Subject: Clarifications to Site Investigation Work Plan – PFAS Contamination
Arkema Coating Resins/Cook Composites & Polymers/Freeman Chemical
340 Railroad Street, Saukville, Wisconsin
BRRTS #: 02-46-000767, FID #: 246004330

In response to the questions and comments provided via email on April 30, 2020, we are providing these clarifications to the PFAS Site Investigation Work Plan prepared for the above-described site. The questions/comments presented in the email are listed below with our response immediately following each bullet point.

Well Construction Diagrams
 Drawing No.:
 Figure No.:

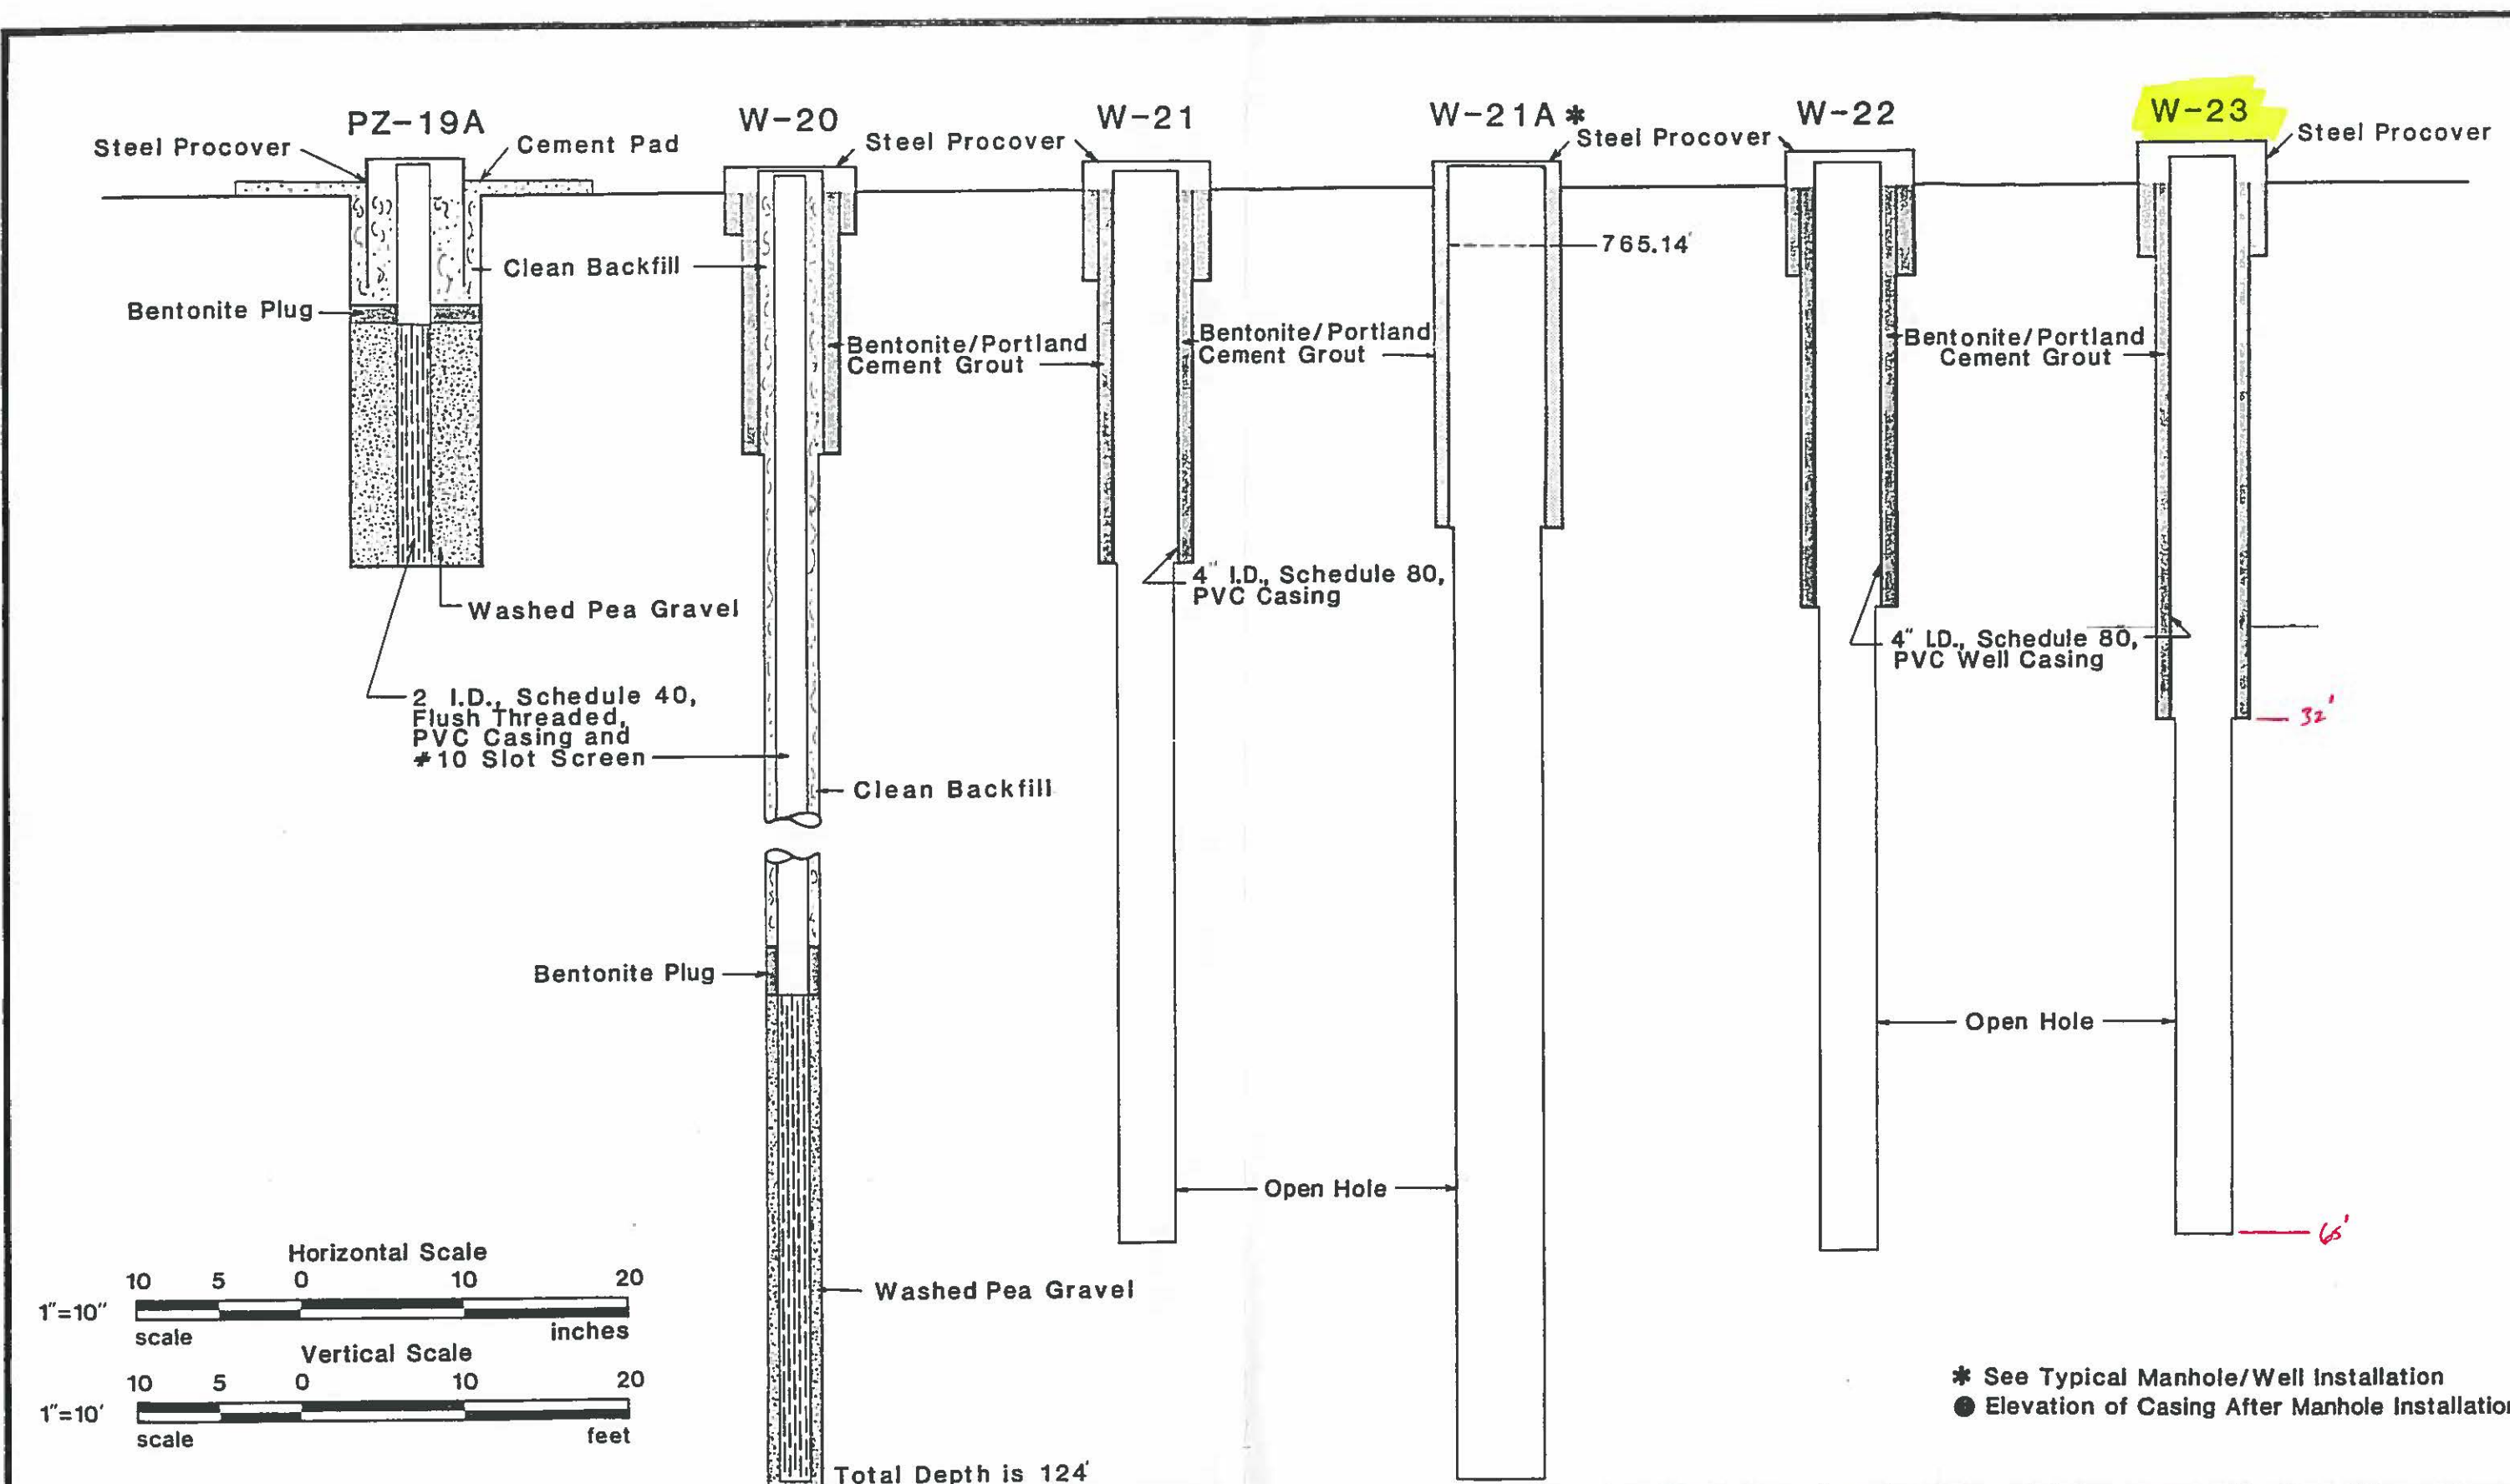
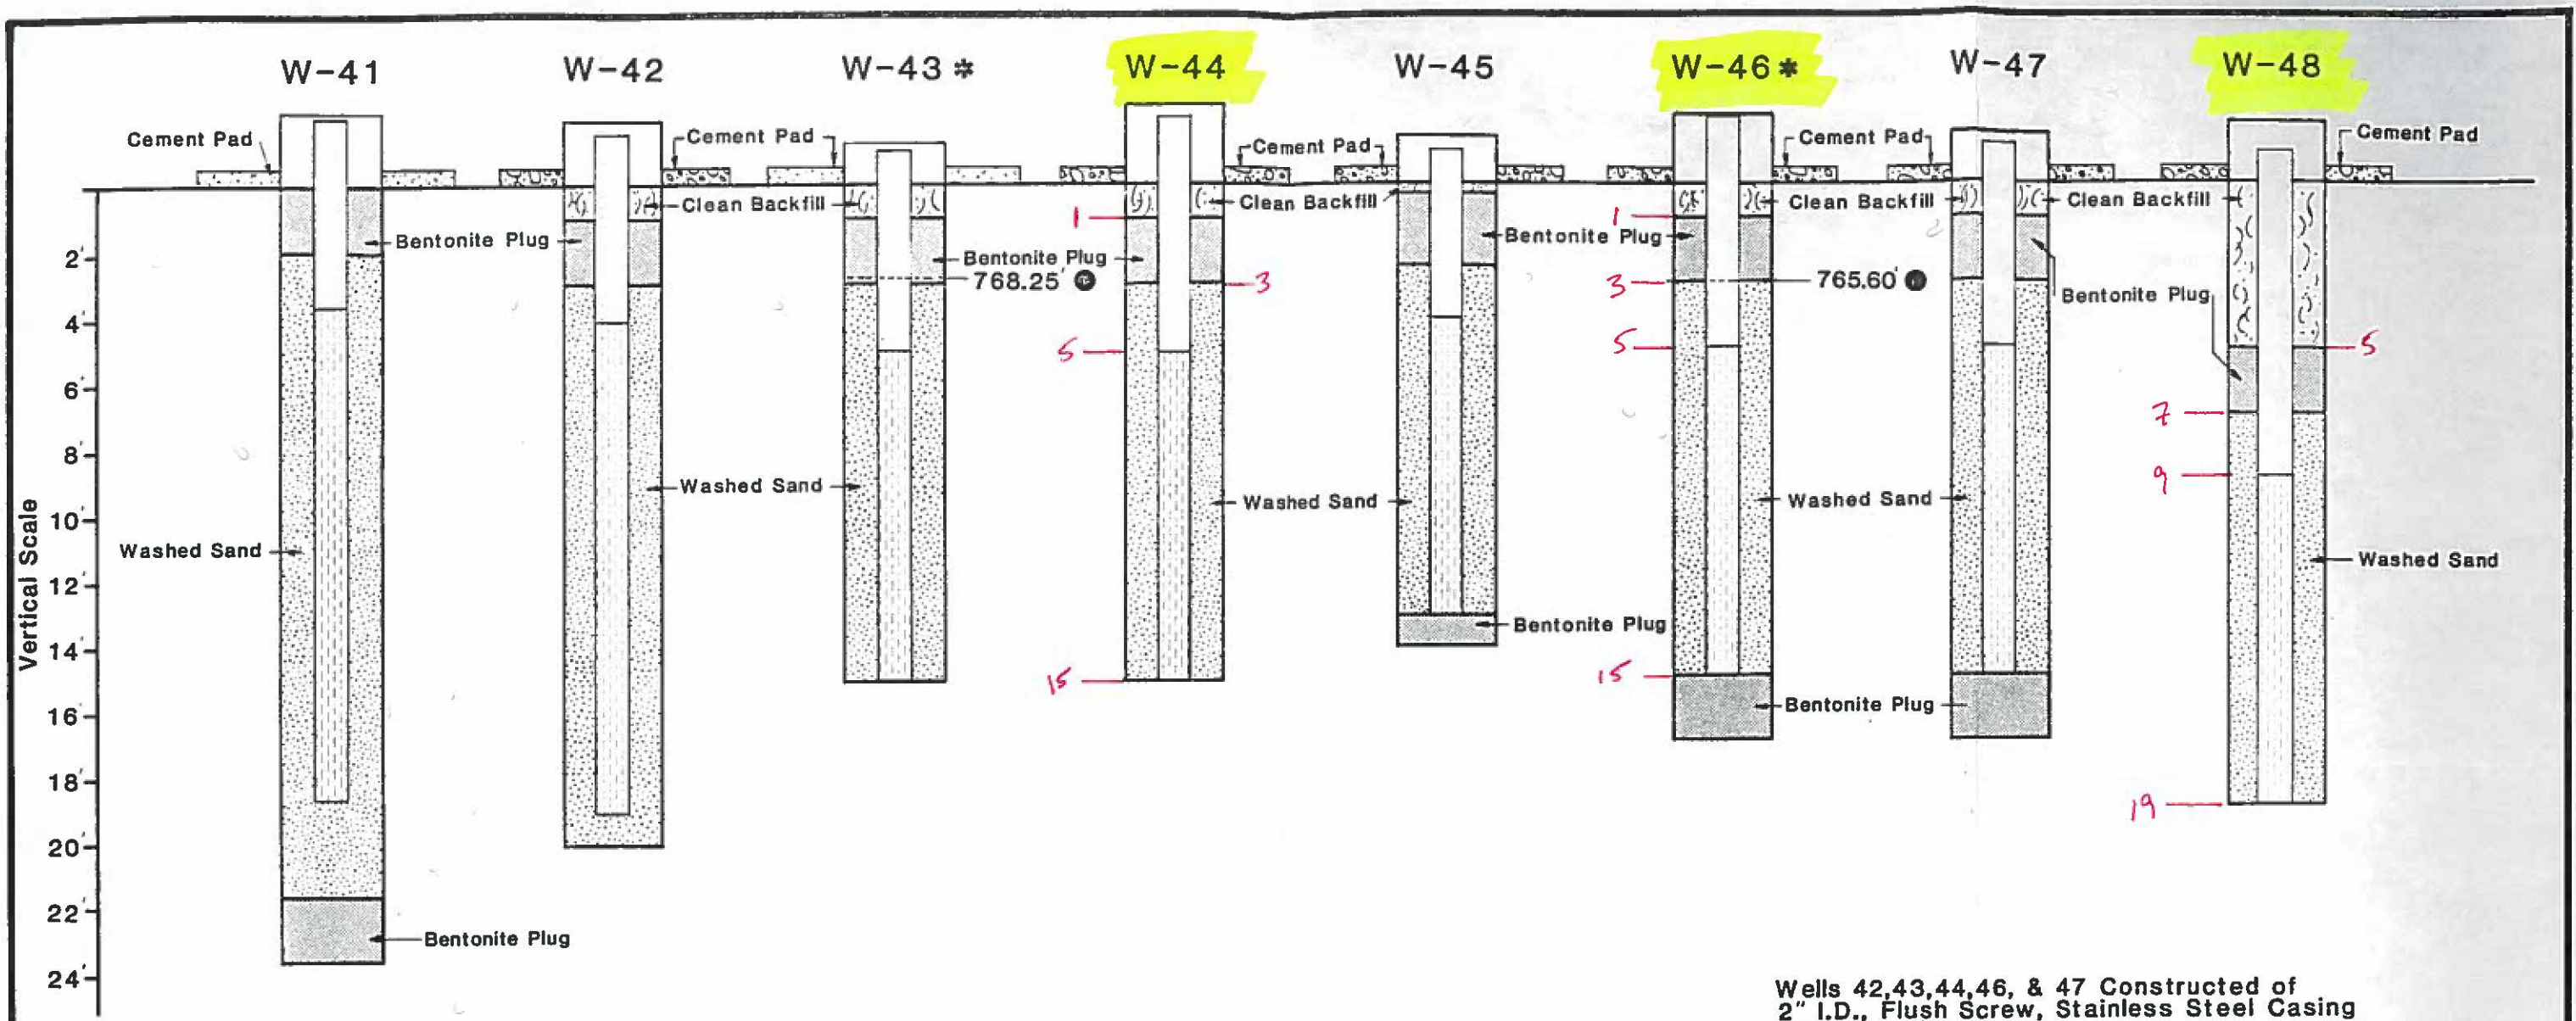
- *Submit well construction details for the wells that are proposed to be sampled.*

Soil boring logs and well construction details for wells W-04, W-08, W-23, W-44, W-46, W-48, W-49 and W-50 are included in **Appendix A**. Please note, W-04, W-08, W-23, W-44, W-46 and W-48 were installed in the early 1980's and the information presented in Appendix A is the extent of the information available regarding these wells. The available information requested regarding soil profiles and well construction details are provided on the attachments.
